Item 4.**Development Application: 108 Swanson Street, Erskineville**

File No.: D/2018/239

Proposal Summary: Change of use of first floor of Swanson Hotel to residential and construction of three new levels for residential use. Alterations and additions including new residential access/lobby from Park Street, introduction of window openings to parapet, removal of roof, and construction of three new levels resulting in a five storey mixed use building comprising 10 residential units and the existing ground floor hotel.

Figure 10: Level 1 Plan.

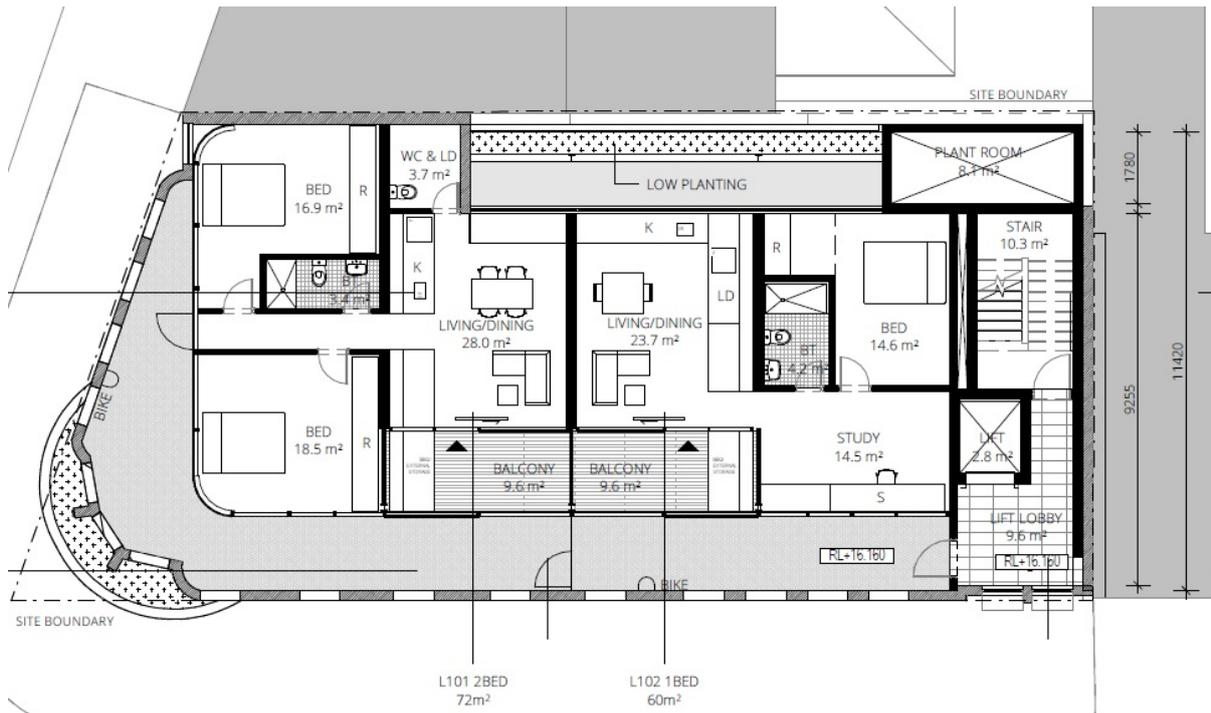
4B Natural Ventilation	Compliance	Comment
All habitable rooms are naturally ventilated.	No	<p>The natural ventilation of habitable rooms on levels 1 and 2 relies on air movement across the breezeway corridors and the removal of existing windows in the facade and introduction of new penetrations in the parapet, which are not supported.</p> <p>The application does not address requirements in the acoustic report which require an acoustically treated alternative source of air to address traffic noise.</p>
Minimum 60% of apartments in the first nine (9) storeys of the building are naturally cross ventilated.	Partial compliance	Similar to above, the degree of cross ventilation achieved relies on air movement across the breezeway corridors and the removal of existing windows in the facade and introduction of new penetrations in the parapet, which are not supported.

Figure 13: West elevation.

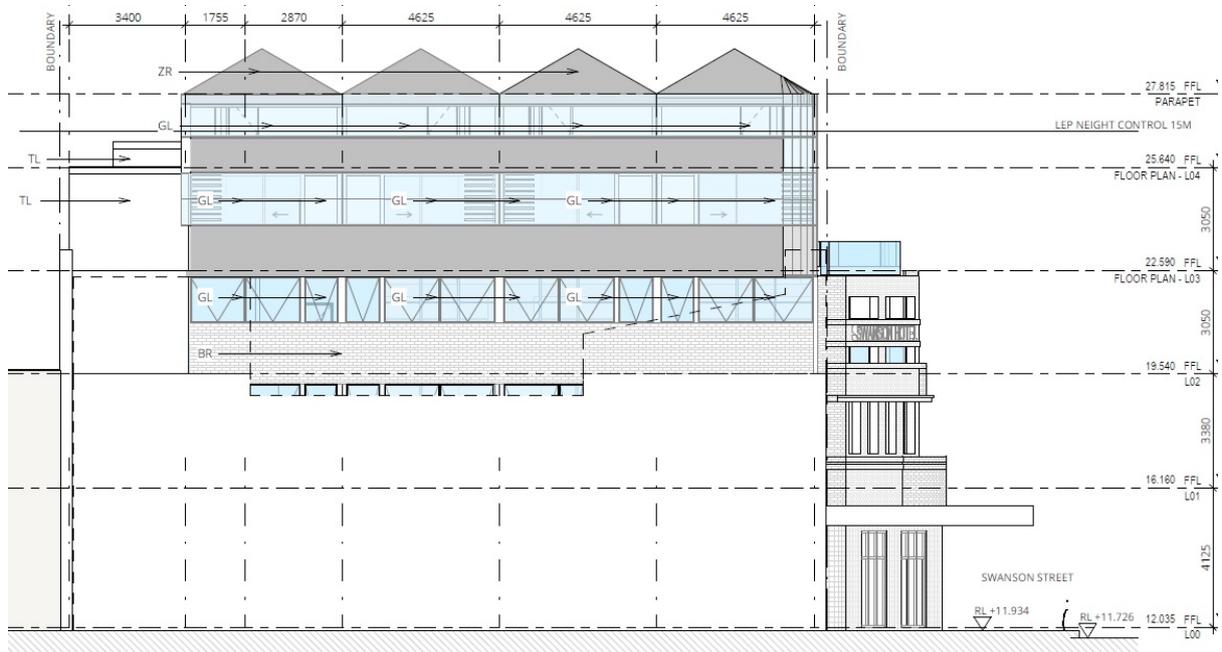
78. Visual and acoustic privacy is an issue both to neighbouring properties and within the proposed development.
79. The western side of the building includes extensive glazing (refer Figure 13) and habitable rooms with separations to the boundary of 2.4m at level 1, 1.0m at Level 2, and 0.3m at Levels 3 and 4. First floor windows are located at No 104 Swanson Street less than 1.0m from the shared western boundary of the site. No privacy treatments are proposed on the plans. The proposal will result in overlooking of windows and private open space of properties to the west and north-west (refer Figure 7).

Figure 19: Feasibility ground slab and footing plan depicting steel perimeter beams and central concrete column and footing.

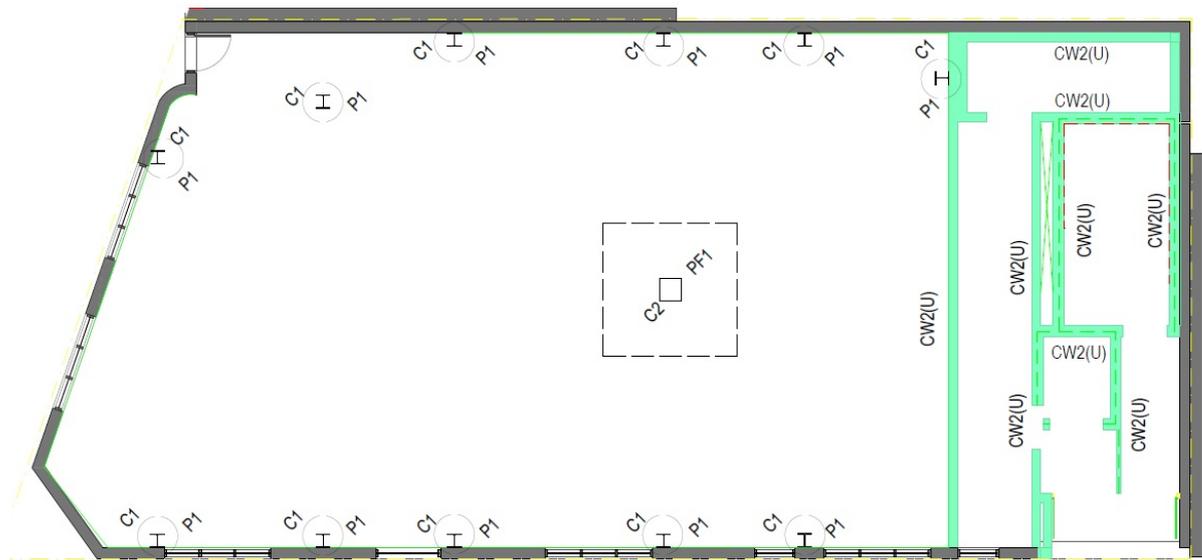
68. As noted earlier in the report, the application seeks to exclude any works to the hotel ground floor and basement, with the exception of the new residential lobby and service area. However, the proposed three storey addition will require substantial structural works to the existing building to support the additional loads. A preliminary structural assessment was included with the application. This assessment indicated a reframing of the first floor, with loads transferred to ground via structural steel portal framing, new concrete footings and a large central concrete column (refer Figure 19).

69. None of these works have been depicted on the architectural plans submitted, or assessed in terms of their potential impact on the original fabric of the building. These works are intrinsically linked to the proposed addition and must form part of the application.
70. The proposal does not comply with the relevant aims, objectives and controls of the Sydney DCP 2012. The proposal will not conserve the heritage significance of the building or the heritage conservation area and is contrary to section 5.10 of the Sydney LEP 2012.

Figure 20: On Level 2, reliance on new penetrations in the principal facade and air movement across the common breezeway and through voids to Level 3 for natural ventilation and cross ventilation.

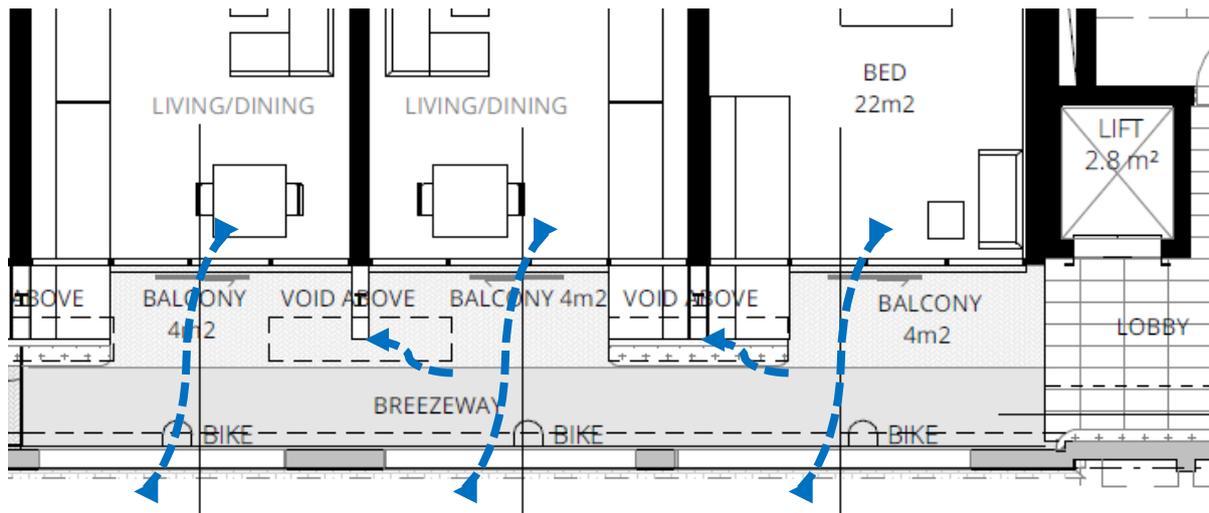
71. The natural ventilation and cross ventilation of habitable rooms on levels 1 and 2 relies on combinations of air movement across the common breezeways, the removal of existing windows in the facade, introduction of new penetrations in the parapet, and the creation of voids within the Level 3 floor (Figure 20). The removal of these windows and new penetrations within the upper parapet are not supported on heritage grounds. In the absence of these openings, natural ventilation of a number of habitable rooms cannot be achieved and natural cross ventilation cannot be achieved.
